September 27, 1994

KENNECOTT UTAH COPPER CORPORATION  
APPLICATION OF MUNICIPAL SEWAGE BIOSOLIDS  
BINGHAM CANYON MINE WASTE ROCK DUMPS  
5816 WASTE ROCK DUMP SLOPE TEST PLOTS

KENECOTT UTAH COPPER CORPORATION  
APPLICATION OF MUNICIPAL SEWAGE BIOSOLIDS  
BINGHAM CANYON MINE WASTE ROCK DUMPS  
NORTH END 5816 EASTSIDE WASTE ROCK DUMP  
TEST PLOT LAYOUT

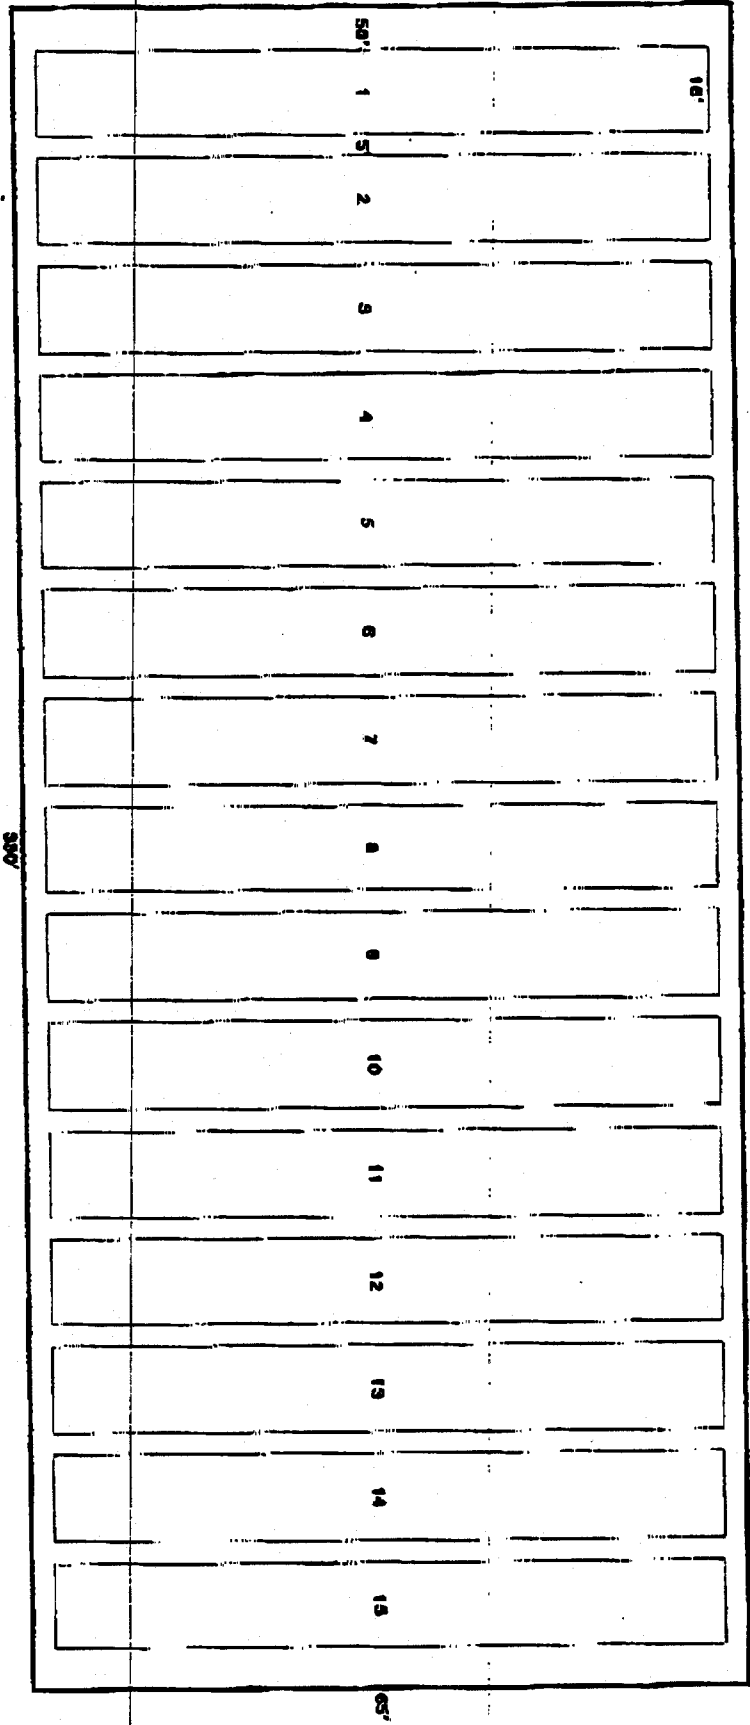
Initially municipal sewage biosolids will be applied to fifteen test plots, each 16 feet wide by 50 feet long. These will be constructed near the toe of the north end of the 5816 Eastside Waste Rock Mine Dump. These test plots replace the 31 test plots, 10 feet wide by 21 feet long, described in the application and shown on Dwg. No. 451-T-1218.

The test plots will be prepared in the waste rock and will be located within the Eastside Collection System which intercepts all water coming from the dumps. The overall dimensions of the test plot area are 65 feet wide by 330 feet long, approximately 0.5 acre.
